## MANUAL IDENTIFICATION

Model Number: 8445B  
 Date Printed: May 1973  
 Part Number: 08445-90103

This supplement contains important information for correcting manual errors and for adapting the manual to instruments containing improvements made after the printing of the manual.

Figure 1. Partial Schematic of Figure 8-10

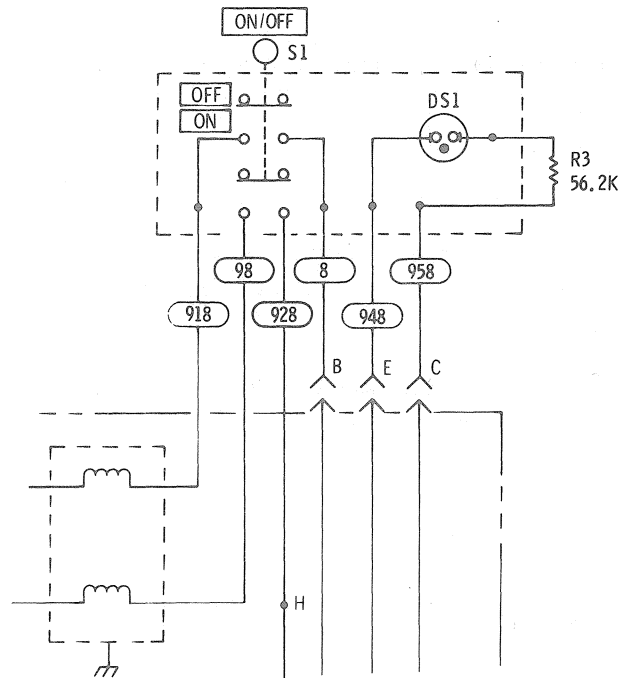
Page 8-23, Figure 8-10 (Service Sheet 6):

Change the diagram as shown in the partial schematic of Figure 1.

Figure 2. Partial Schematic of Figure 8-9.

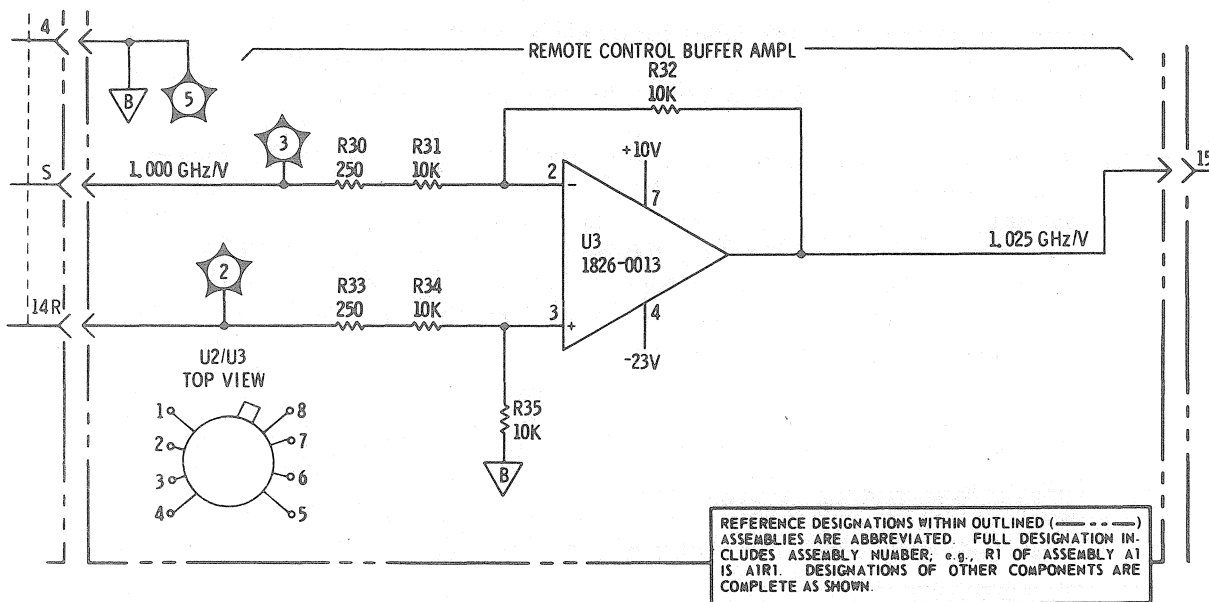
Page 8-9, Figure 8-21 (Service Sheet 5):

Change the circuit diagram as shown in the partial schematic Figure 2.
